AGENDA

PLAN COMMISSION MEETING

Thursday – August 30, 2018 – 7:00 p.m.

3. Planned Unit Development – Maplewood Farms

REZONING EXHIBIT "A"

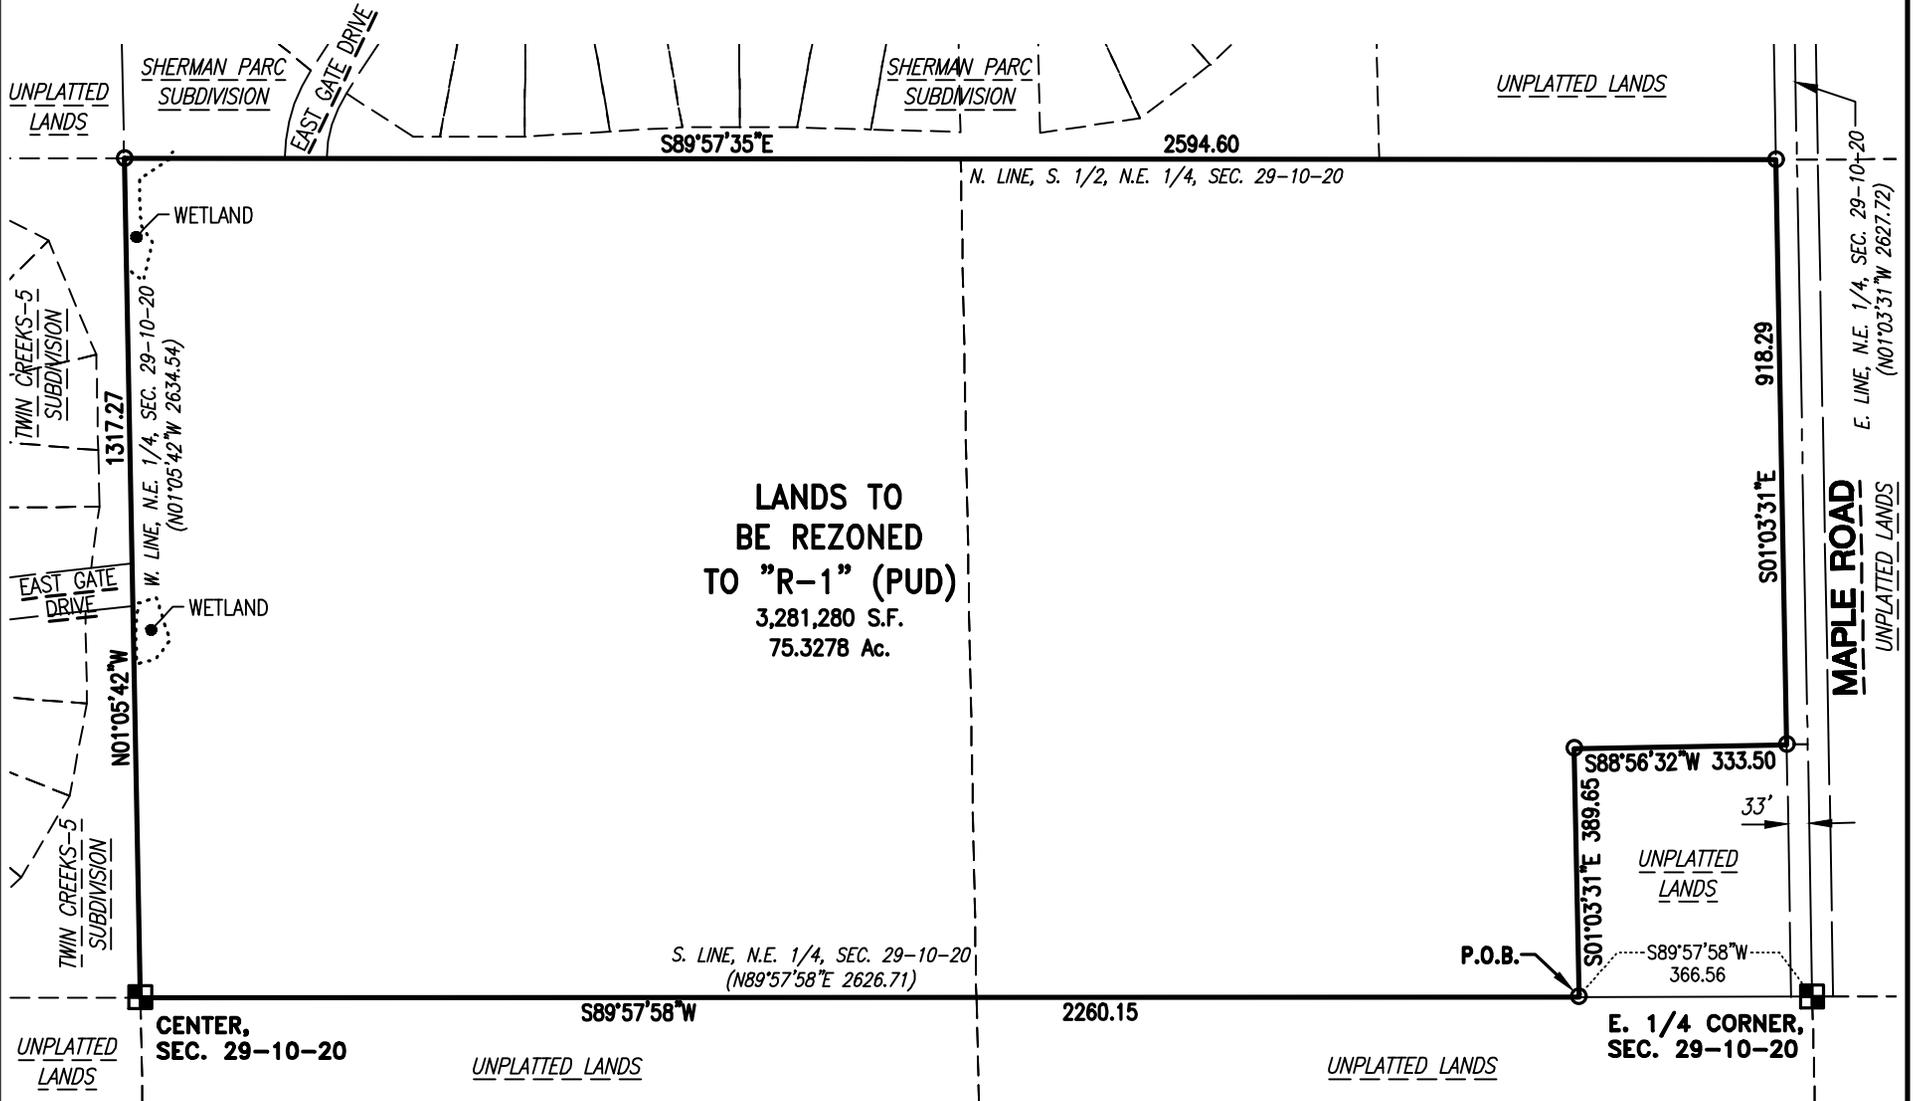
- Recommend a PUD Zoning classification
- Recommend the setbacks as proposed by the developer (30'0" front, 25'0" rear, 10'0" & 15'0" = 25'0" sides.)
- On the Rezoning Exhibit and Preliminary Plat: change the "proposed zoning R-1 (PUD)" to just PUD.

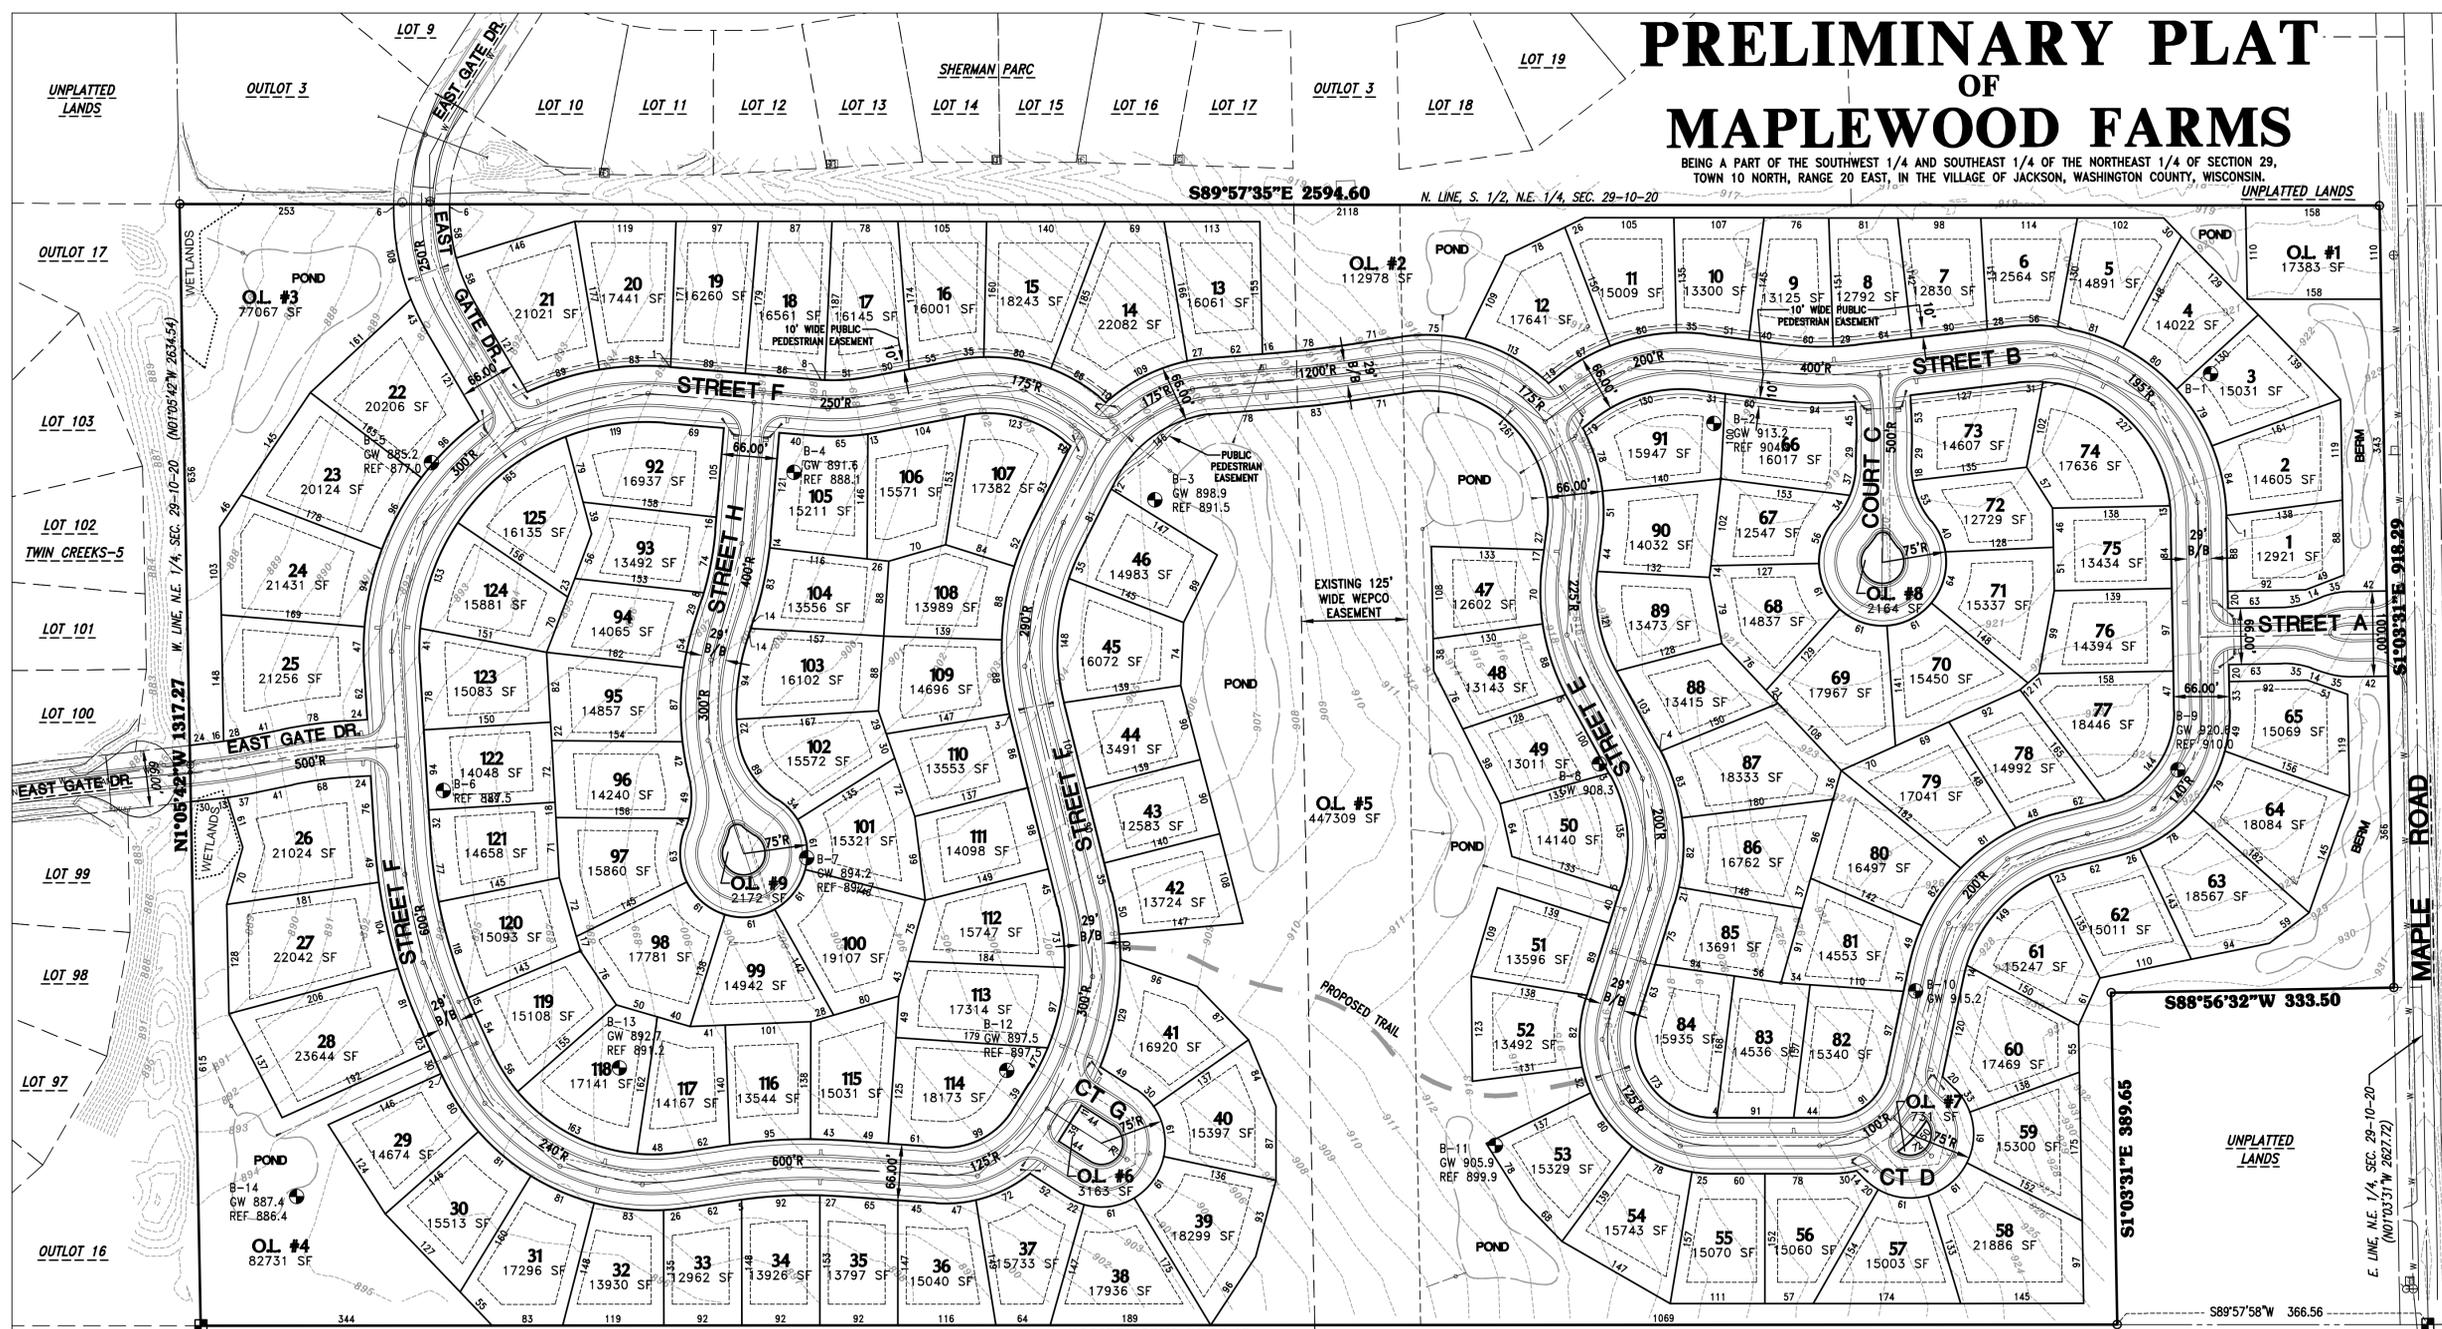
- The zoning is PUD-Residential and not R-1 zoning. The proposed setback on the plan is recommended for approval.
- The approved road section is in the plan set with sidewalks, ditches for drainage, and roll face curbing.
- Verifying the yard grade and garage floor grade on the final grading plan will be discussed during plan review process.
